Product Change Notification / ALAN-05WOJS872

CCB 3012.002 Final Notice: Qualification of MMT as an additional assembly site for selected Atmel ATTINY102 device family available in 8L SOIC (150mils) package.

**CCB 3012.002**  
**Pre and Post Change Summary**  
**PCN# ALAN-05WOJS872**

## Pre Change

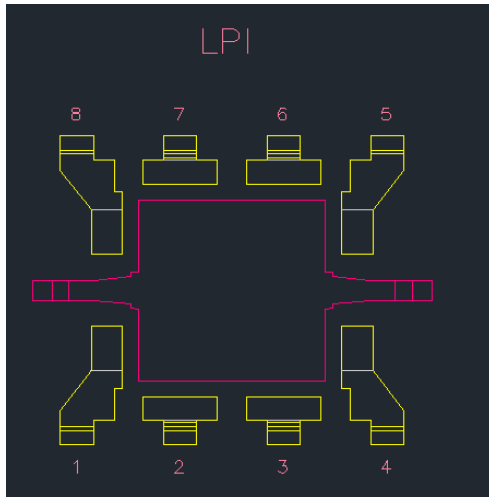
<b>Assembly Location</b>		Lingsen Precision Industries, Limited (LPI)
<b>Bond Wire Material</b>		CuPdAu
<b>Die Attach material</b>		CRM-1033BF
<b>Mold compound material</b>		G600
<b>Lead-Frame</b>	<b>Lead-lock</b>	No

## Post Change

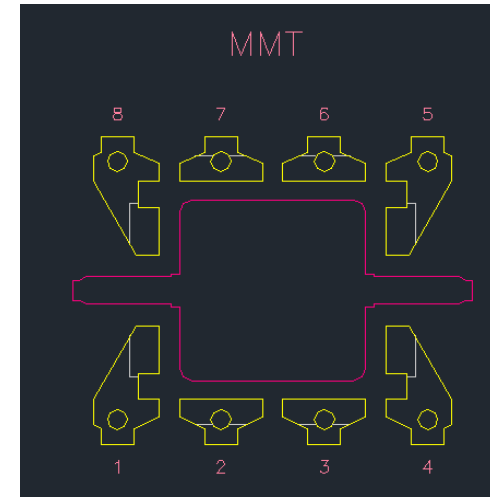
<b>Assembly Location</b>		Microchip Technology Thailand (MMT)
<b>Bond Wire Material</b>		Au
<b>Die Attach material</b>		8390A
<b>Mold compound material</b>		G600
<b>Lead-Frame</b>	<b>Lead-lock</b>	Yes

\*Note: Mold compound material fills the lead lock hole, which provides improved protection against moisture penetration along the edge of the leads (pins) of the package.”
